RAIL POST & ANCHORAGE DETAILS

G.S.I. HIGHWAY PRODUCTS		
720 W. WINTERGREEN RD., HUTCHINS, TEXAS 75141 (972) 225-1660		
CONTRACTOR: RUSSELL ENGINEERING		
SCALE: NONE	GSI#: 1037-1	DATE: 09/28/06
REVISED:	CHECKED:	DRAWN: DUGAN
BROWARD COUNTY S.R. 842		
FP ID 227861-1-52-01		BROWARD COUNTY 86006
TYPE C4(S) RAIL	FABRICATION WALL "D"	13 / 14

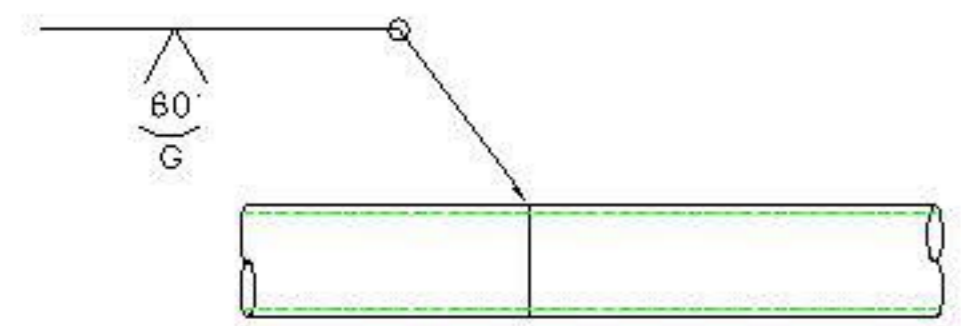
- $\triangle 1$ Base plate and anchorage modified per HP Engineer's report "Adhesive Anchor Design", dated 8/2006.
- $\triangle 2$ Post upright modified to incorporate latest DOT approved enhancements:
 - Post notched to accept 2" pipe handrail.
 - Fillet weld at 2" pipe increased from $\frac{1}{8}$ " to $\frac{1}{4}$ ".
 - Upright-to-baseplate connection increased to 6" with $\frac{3}{16}$ " fillet weld.
